Meeting Date: Tuesday 8 December 2015
Location: Committee Room 2, Level 5, Civic Centre, 1 Devlin Street, Ryde
Time: 5.00pm

NOTICE OF BUSINESS

2 95 BALACLAVA ROAD, EASTWOOD - LOT 6 DP 35226 Development Application for a new two storey boarding house comprising twelve (12) boarding rooms under State Environmental Planning Policy (Affordable Rental Housing) 2009. LDA2015/11.

**3 38 CONRAD STREET, NORTH RYDE - LOT 23 DP 222878. Section 96(1A)
Application to modify consent for alterations and additions to dwelling.**

Figure 9 - Northern elevation windows with indicative location of existing 1.8m boundary fence considered acceptable for maintaining visual privacy from the ground floor windows.

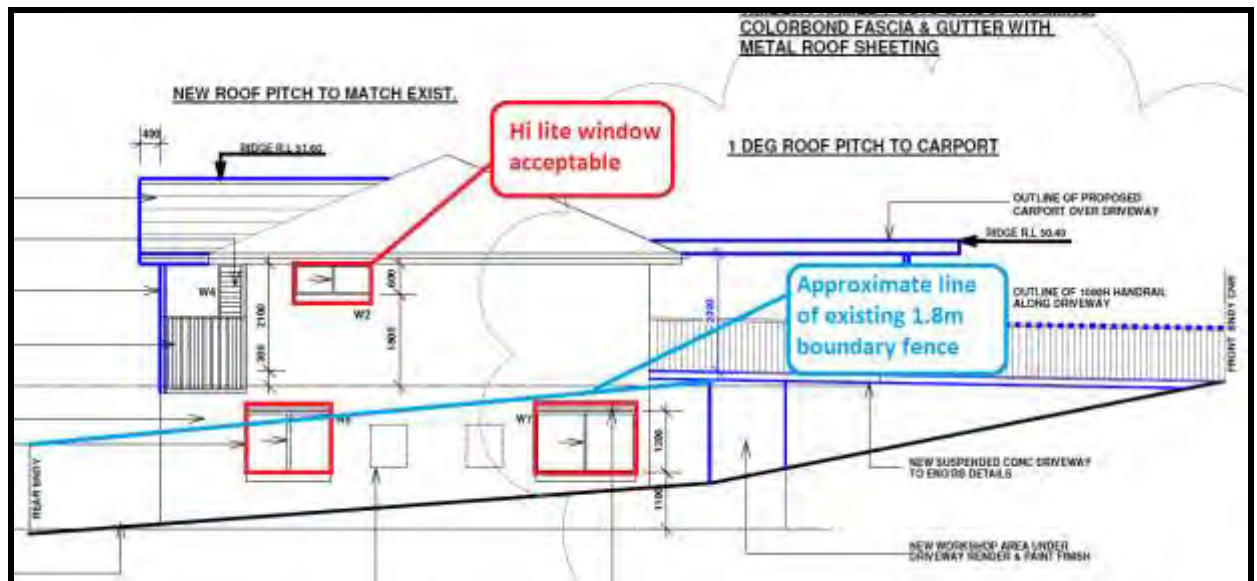
Assessment Officer Comment: An analysis of the proposed windows on the northern elevation has revealed that the first floor window is a highlight window with a sill height of 1.8m. The ground floor windows are considered to be acceptable - refer **Figure 9**. This is because there is currently a 1.8m boundary fence which will prevent overlooking into the neighbouring private open space. Further an analysis of the southern elevation of the adjacent dwelling reveals that living area windows are located at the first floor and due to the site orientation, these windows face the street frontage and front setback areas of No.38 Conrad Street not the side boundary.

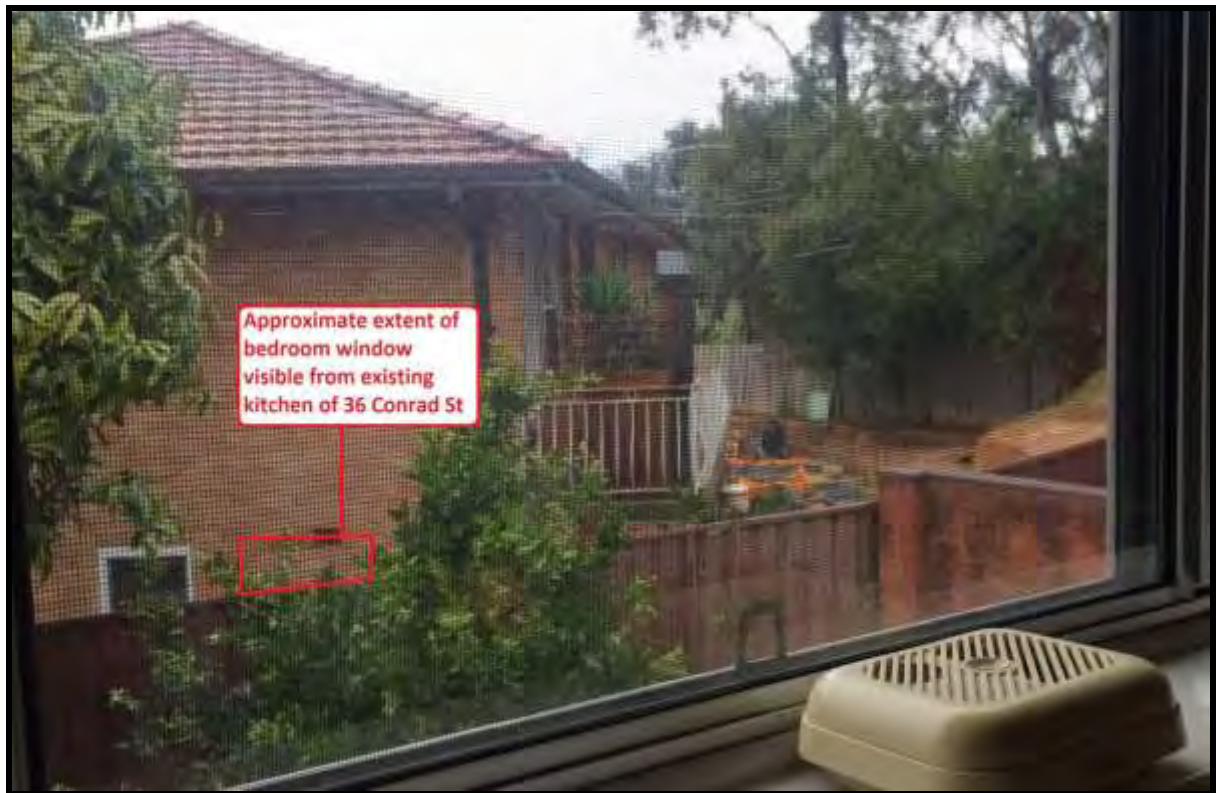
The following photograph illustrates the existing fence providing adequate mitigation to visual privacy - refer Figure 10.

Figure 11 - Workshop shown within the envelope of the driveway and 6.5m from the front boundary. Note that the door to workshop opens to the south and that no windows are proposed.
Source: Submitted plans by applicant edited for diagrammatic purposes by CPS.

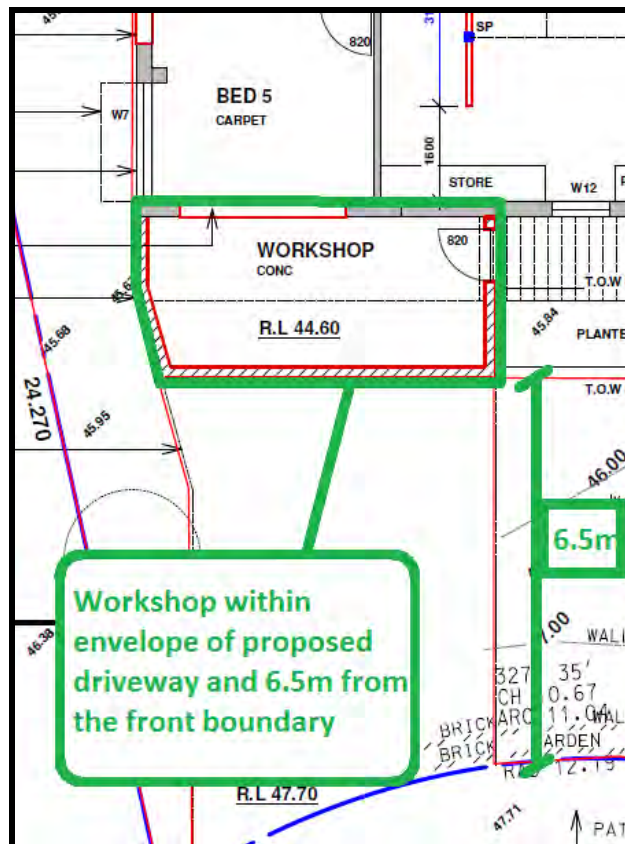
Whilst workshop is part of a structure that could be considered a visually prominent element within the streetscape, it is noted that a structure is already approved and if constructed would have a similar visual prominence. Nevertheless it is considered that the proposed workshop within the envelope of this structure does not necessarily increase its visual prominence - refer to **Figure 11** below.

Figure 12 - Physical separation between driveway and pedestrian pathway in the form of a low level wall or planter to be provided by a condition of consent.

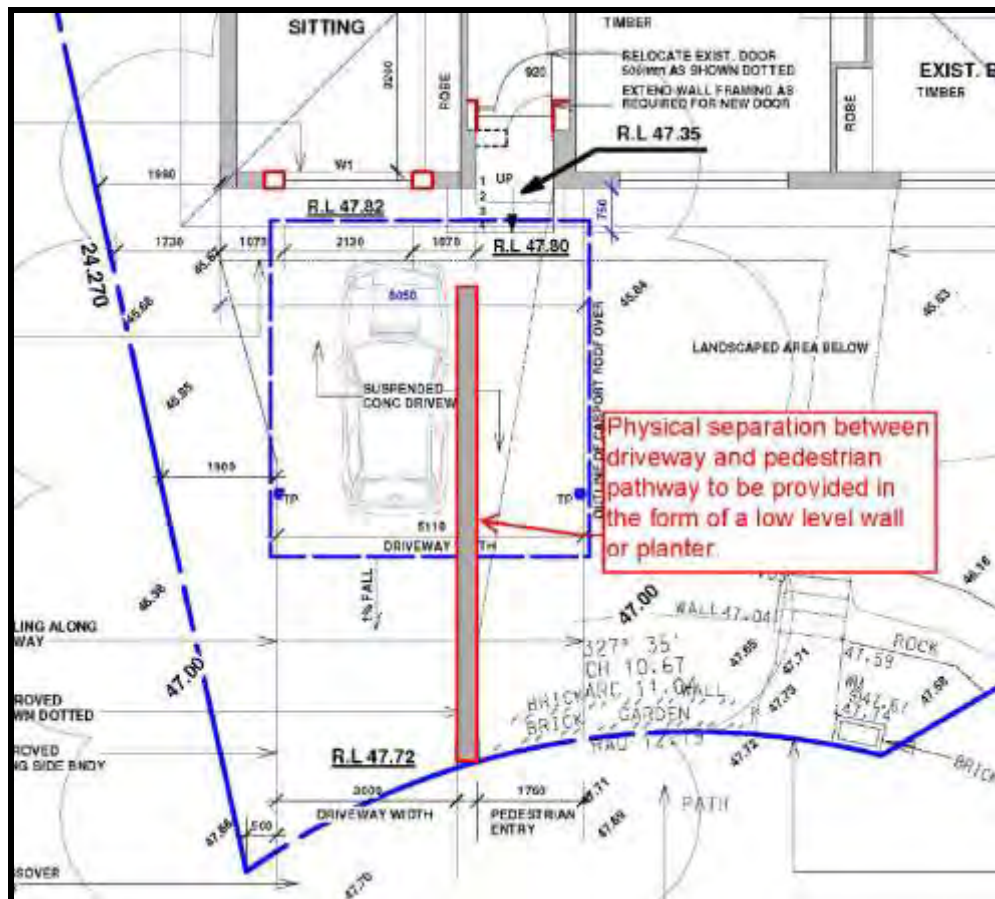
Pedestrian Pathway - Physical separation be placed between the pedestrian and driveway components of the elevated parking structure via a low level wall, bollard, or planter etc. Plans detailing compliance with this condition are to be submitted to Council for approval prior to the issue of a **Construction Certificate** works covered in the plans under Condition 1.

Figure 1 - Driveway and parking option

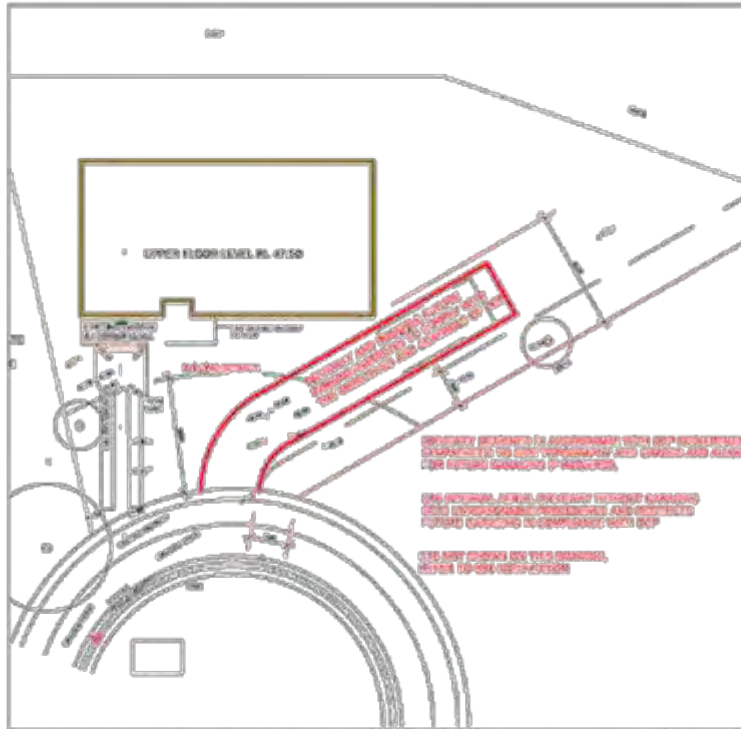
A more skilful design is demonstrated by the concept in figure 1, that deliver a safer driveway grades demonstrated in figure 2 and parking of vehicles behind the building line.

Please note in green the existing ground level and the alternative driveway grades that could be achieved by a more skilful design.

Figure 4 – Unit 3 indicating the proposed bay window resulting in encroachment to the 3m side setback.

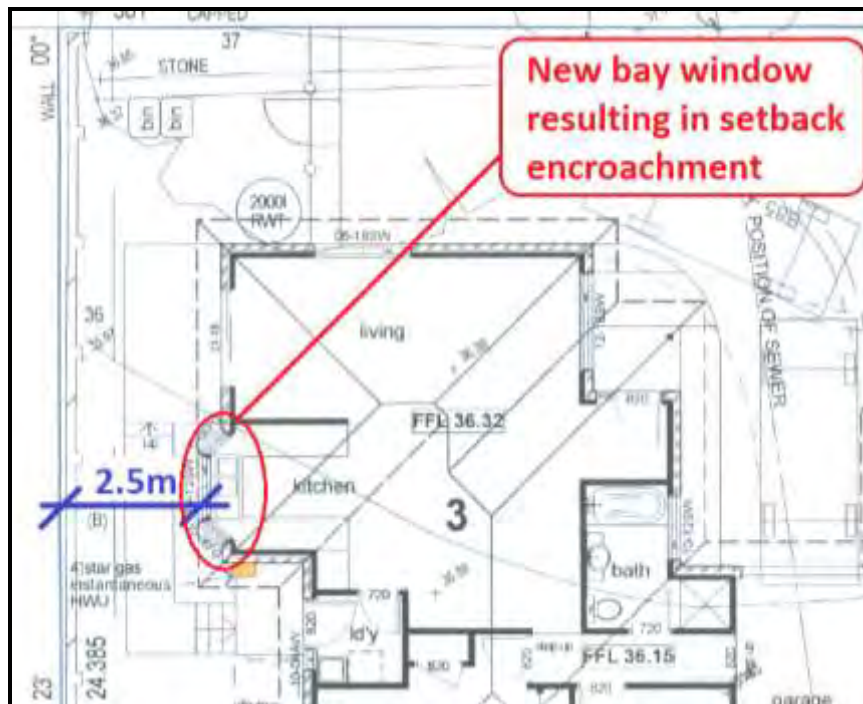
An assessment of the proposed Section 96(1A) modifications has revealed that the setbacks to north-eastern and north-western side boundaries have been reduced to 2.5m as a result of the introduction of bay windows to the dining room of Unit 1 and the kitchen of Unit 3 respectively – refer to **Figure 4** and **Figure 5**. Whilst the proposed setbacks do not meet the minimum requirements as mentioned above, it is considered the variation to Council's controls is minor and can be supported for the following reasons:

Figure 6 – Plan and elevation indicating the height of the proposed deck for Unit 2.
Source: Submitted plans by applicant edited for diagrammatic purposes by CPS.

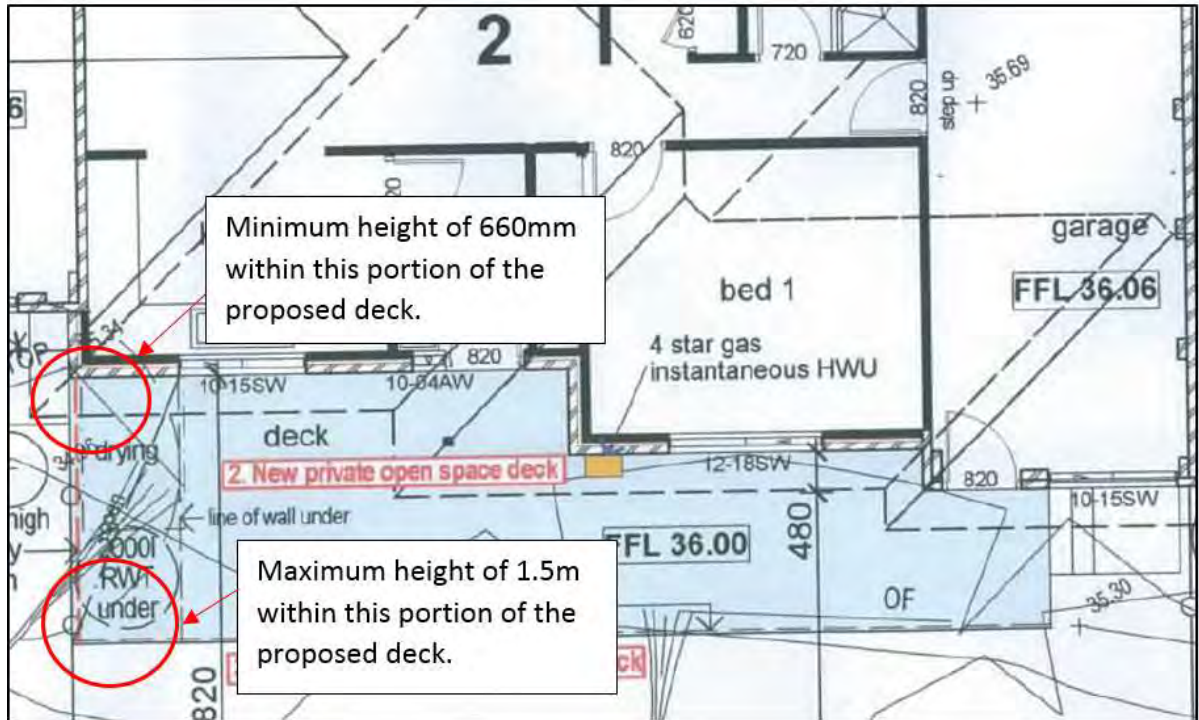
- The height of the deck for Unit 2, which is referred to a deck on the submitted plans, has a maximum height of 1.5m, which reduces to a height of approximately 660mm above the existing ground level. Due to the variation in the height of the deck, where the maximum height of 1.5m occurs only within a small portion, it is considered that the overall height of the deck is not excessive and would on its own, not result in significant overlooking to the adjoining properties – refer **Figure 6**
- The location and orientation of the deck will not result in direct overlooking into the private open space of adjoining properties. This is because the deck is adequately separated the private open space and habitable room windows of adjoining properties. Furthermore, adjoining properties and substantially screened from the subject site, by existing mature vegetation – refer **Figure 7**.
